SPRING CREEK 2ND ADDITION

S/D 98-48 -- Final Plat of SPRING CREEK SECOND ADDITION

Re: S/D 98-48 -- Preliminary Plat of SPRING CREEK 2ND ADDITION

CASE NUMBER: S/D 98-48 - SPRING CREEK 2ND ADDITION

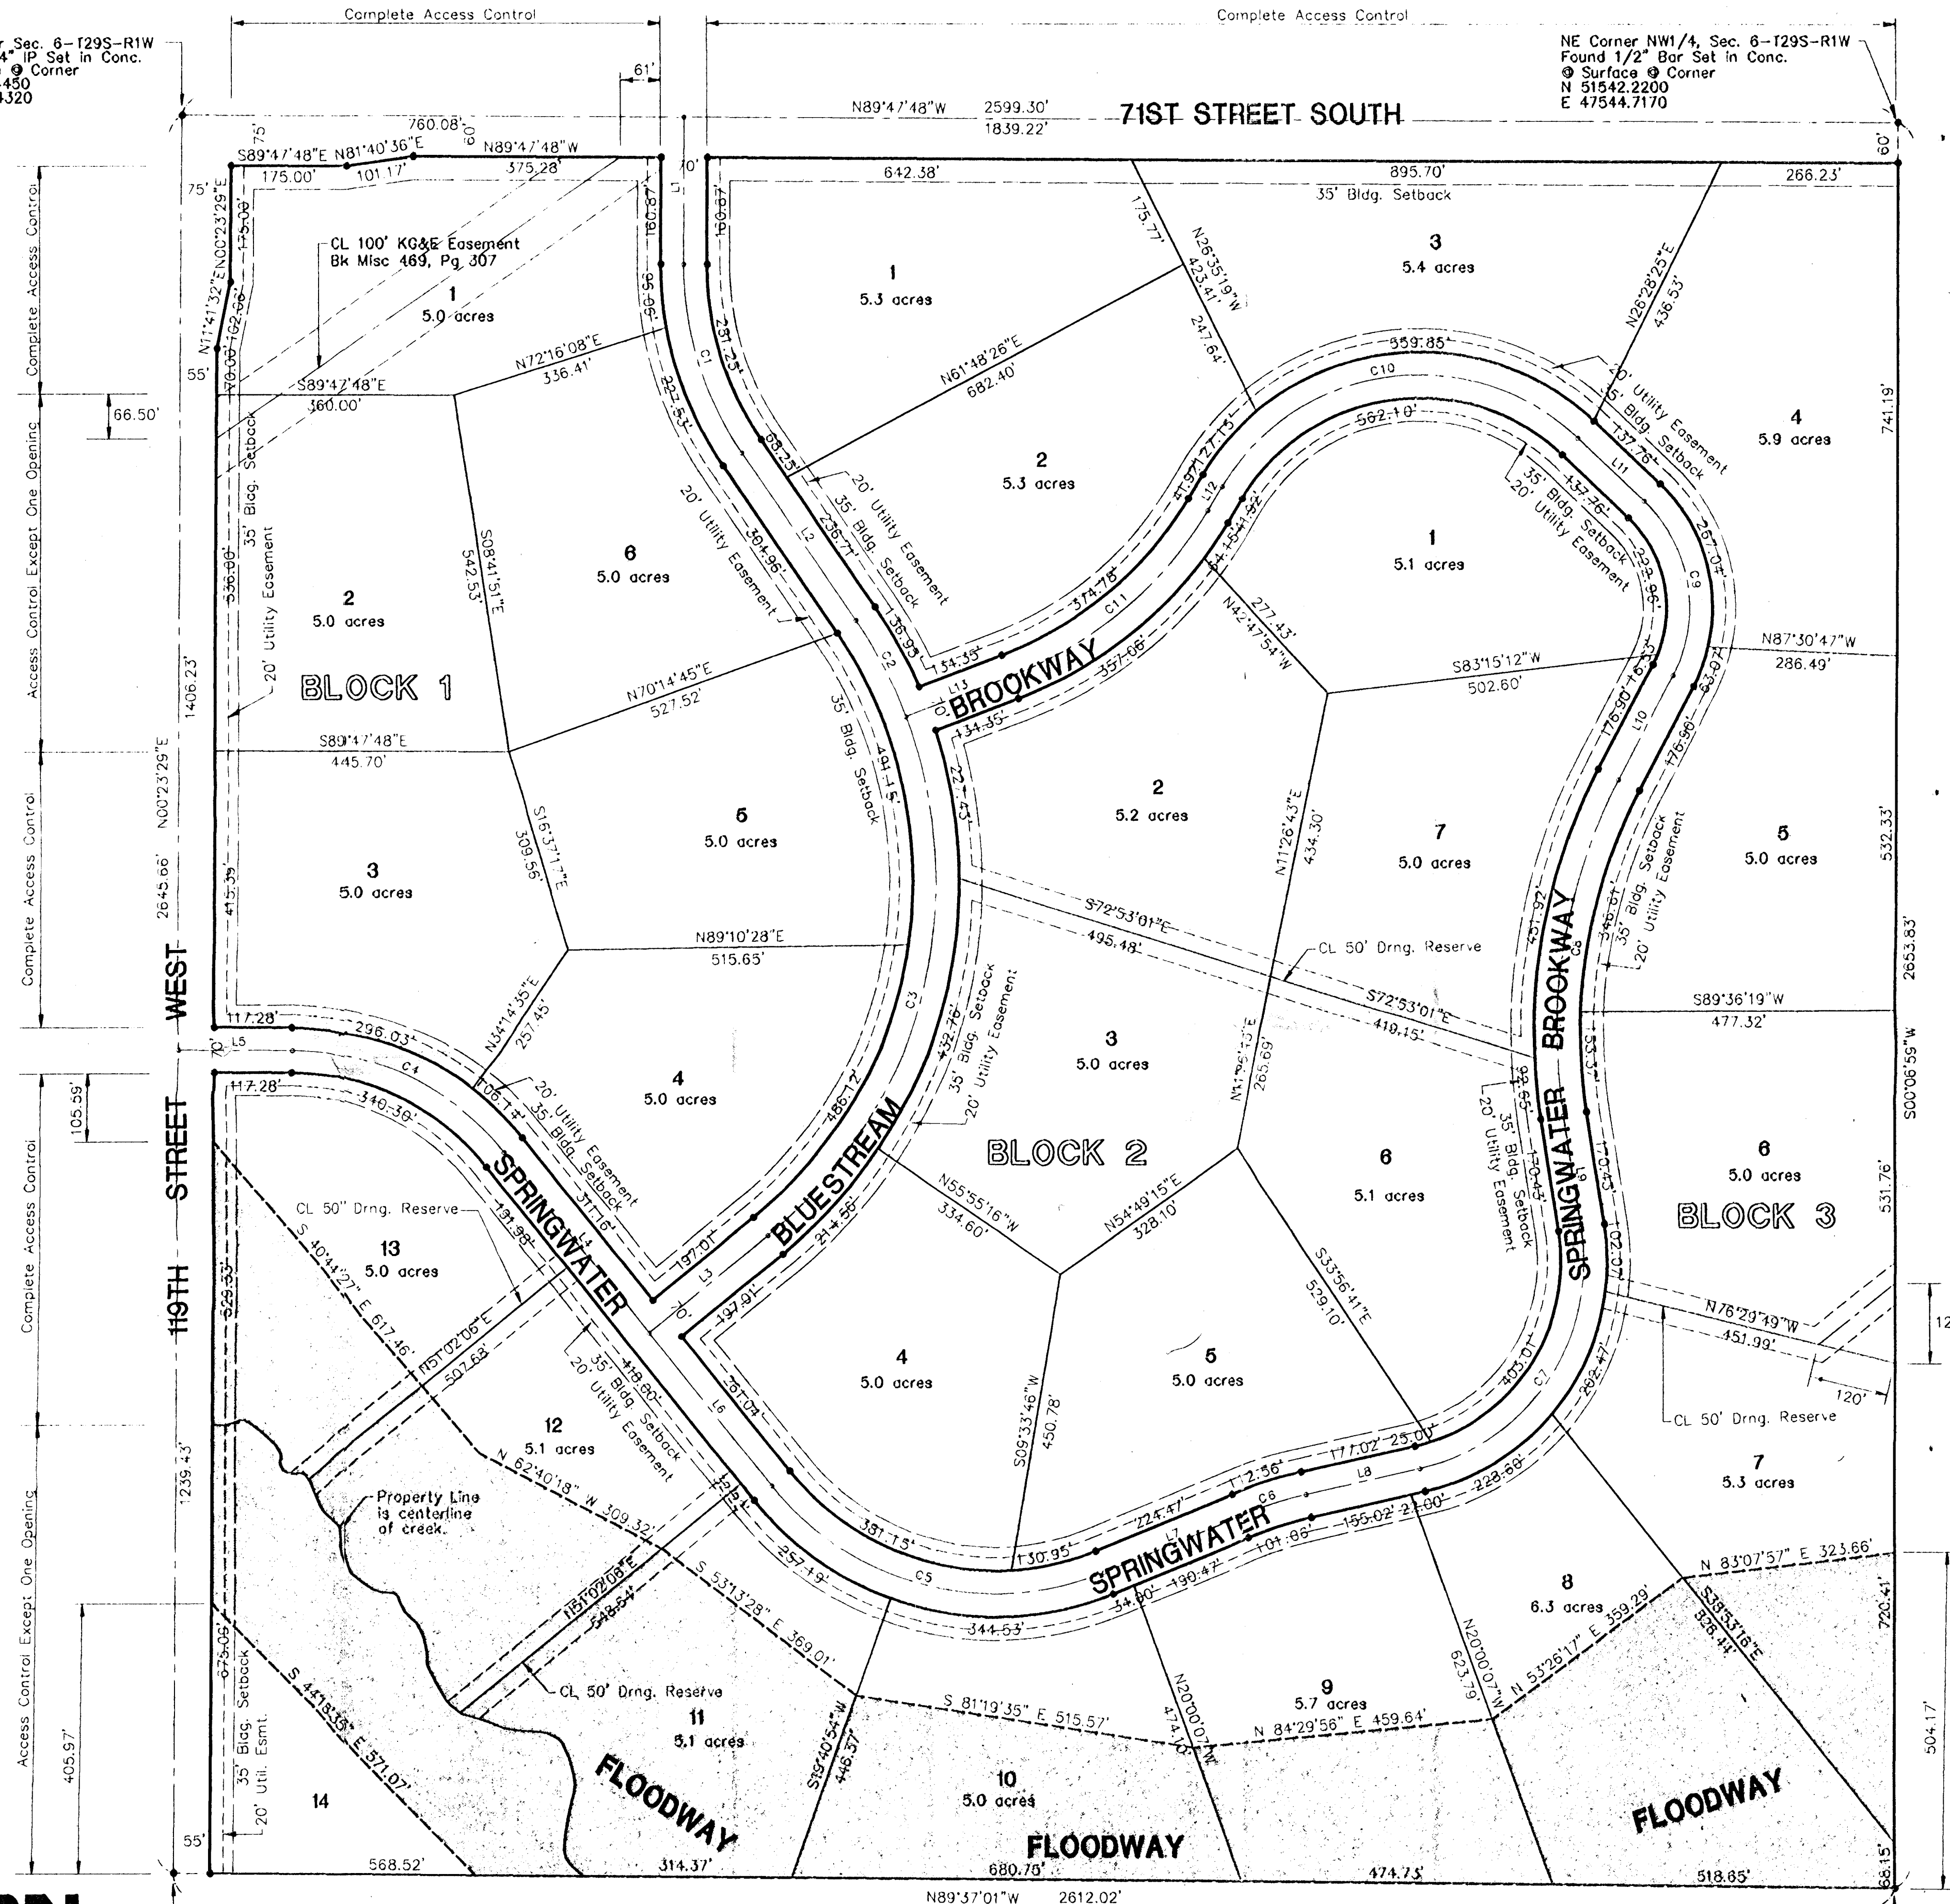
- C. County Engineering needs to comment on the status of the applicant's drainage plan. Flood elevations need to be established. FEMA approval will be needed if floodplain width is to be reduced. The drainage easements need to be increased to 50 feet and relabelled as drainage reserves.

- F. The County Commissioners signature block need only include the signature of the Chairman.
- G. The tie points should be revised to read, "NE corner NW 1/4" and "SW corner of NW 1/4".

- I. Lot numbers in each block should be revised in the final plat, to include consecutively numbered adjoining lots.
- J. County Fire Department needs to comment on the acceptability of the proposed street names. *The suffix "drive" should be eliminated for the streets in this plat as it is only appropriate for streets parallel to that of a street of the same name. Artesian Drive shall be eliminated.*

- K. *The floodway language in the plat's text shall be revised to reference "the engineer of the appropriate governing body" rather than the "Wichita Valley Center Flood Control Office".*
